SERVICE BULLETIN

No. 301A

Reissued Airplane Flight Manual and New Placards
(Reference FAA Airworthiness Directive for PA-30 dated
November 5, 1969)

PA-30 Twin Comanche

Sketch "A"

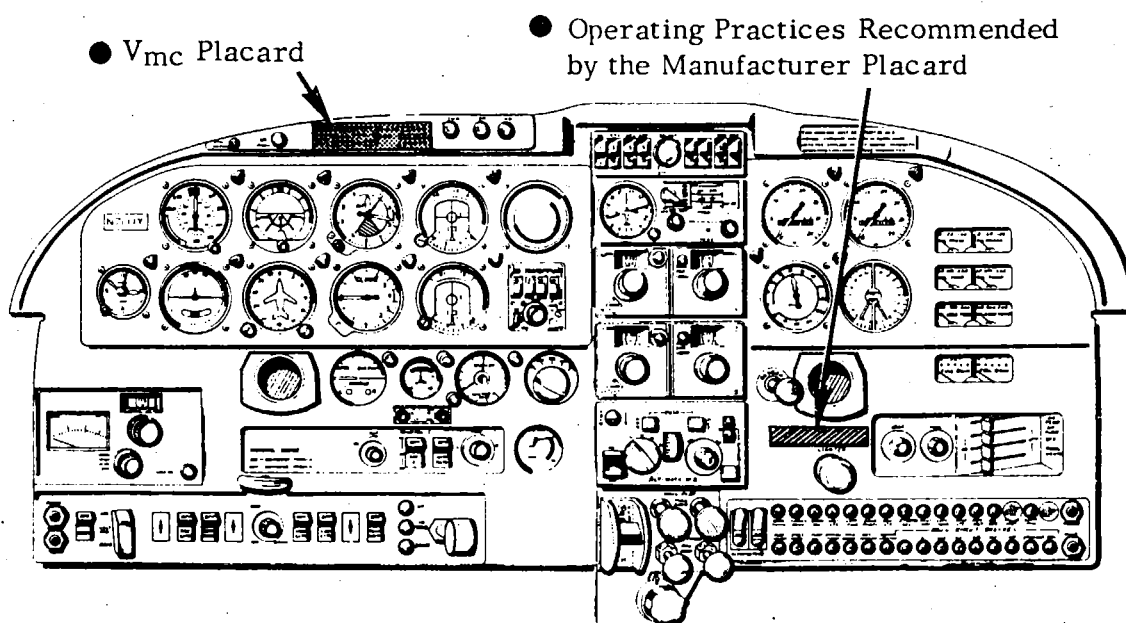
- I. Aircraft serial numbers 30-1 to 30-1716, 30-1718 to 30-1744 incl.:
 - A. Remove or cover existing minimum single engine control speed placard and install new Vmc placard, per sketch A, page 3 of this bulletin.
 - B. Install new operating practices recommended by the manufacturer placard, located as denoted on Sketch A, page 3 of this bulletin.
 - C. Replace existing Section 1, Airplane Flight Manual Report No. 1269 with reissued Section 1 (reissue date 11/15/69), Airplane Flight Manual Report No. 1269, supplied with Vmc Placard Installation Kit part number 760 354 (reference Material Required, below).
- II. Aircraft serial numbers 30-1717, 30-1745 to 30-2000 incl.:

Serial numbers 30-1 to 30-1716 inclusive, 30-1718 to 30-1744 inclusive
